LARAMIE COUNTY PLANNING & DEVELOPMENT DEPARTMENT

MEMORANDUM

TITLE: PUBLIC HEARING regarding a Solar Energy Site Plan and Solar Energy Permit for the Cowboy Solar I & II Project, Situated in Sections 30, 29, 28, 27, 26, and 35 of Township 13 North, Range 65 West, as well as Sections 26 and 25, Township 13 North, Range 66 West, and Section 2 of Township 12 North, Range 65 West of the 6th P.M., Laramie County, WY.

Figure 1

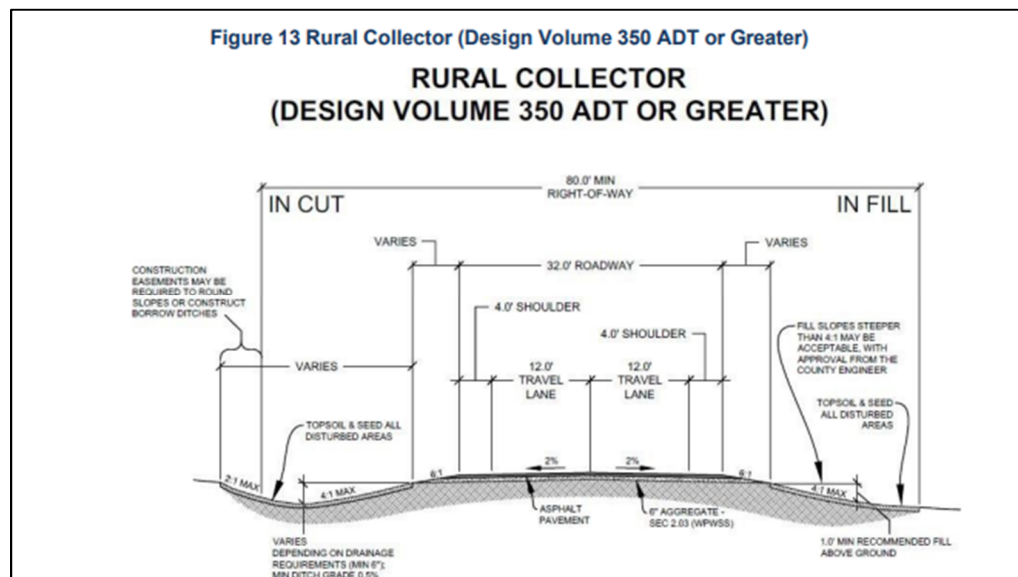
Due to the impact this development action will have, Chalk Bluff Road (Road 203) will need to be upgraded to meet the current Laramie County Land Use Regulations (2022 LCLUR amended October 4, 2022) from US85 to the northernmost project access point prior to any on-site construction taking place. This equates to approximately nine miles of road improvements. See Figure 1 which shows a cross section detail of the current standard.

The table shows a steady increase in the use of Chalk Bluff Road, with 2023 showing 675 average daily traffic (ADT). Based on the Traffic Study provided by Cowboy Solar, construction of the project will add 810 daily trips to Chalk Bluff Road. We have seen the road degrading as traffic has increased and the impact of these additional vehicles will, undoubtedly, cause degradation to the point of failure.

Chalk Bluff Road from US85 to the end of the existing asphalt (approx. 7.7 miles) will require improvements and upgrades due to the significant impact. Laramie County will require Cowboy Solar to upgrade the existing asphalt section to the current standard (Figure 1) within the Laramie County Land Use Regulations, prior to any on-site construction taking place.

The Laramie County Land Use Regulations, require Cowboy Solar to upgrade the gravel section of Chalk Bluff Road from the end of existing pavement to the northernmost project access point (1.3 miles). This roadway section will be required to meet the “Rural Collector (Design Volume 350 ADT or Greater)” cross section as shown in Figure 1. The upgrades shall be completed prior to any on-site construction taking place.

Figure 1. Chalk Bluff Road ADT

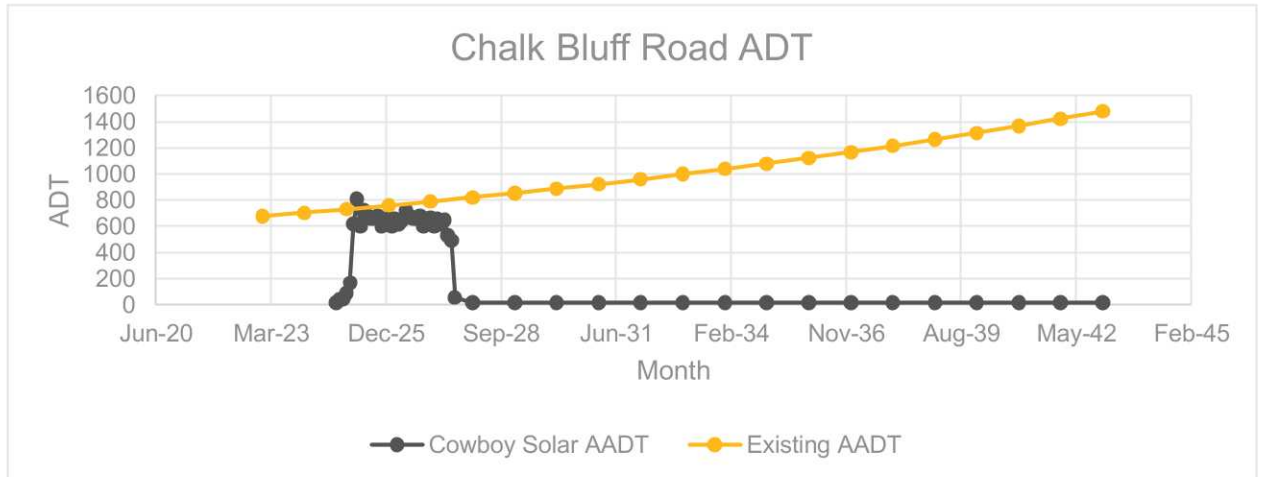
2. The Laramie County Land Use Regulations, require Cowboy Solar to upgrade the gravel section of Chalk Bluff Road from the end of existing pavement to the northernmost project access point (1.3 miles). This roadway section will be required to meet the Rural Collector (Design Volume 350 ADT or Greater) cross section as shown in Figure 13. The upgrades shall be completed prior to any on-site construction taking place. A right-of-way/grading permit will be required.

The chart in Figure 1 shows a projection of the anticipated ADT on Chalk Bluff Road over the next 20 years. Note that 20 years is a standard pavement design life, and would likely be the design life of the reconstructed pavement referenced in the Letter.

The black line in Figure 1 shows a projection of the Cowboy Solar Project traffic over the next 20 years. As evident from Figure 1, the Cowboy Solar traffic peaks during the construction of the project (approximately a 2.5-year period). The ADT then drops to approximately 15 small Operation and Maintenance vehicles a day. The orange line in Figure 1 shows a projection of the existing traffic on Chalk Bluff Road over the next 20 years. The traffic growth rate was calculated by using the historical Chalk Bluff Road ADT data provided in the letter. Note that Figure 1 shows ADT, which does not include a measure of vehicle type.
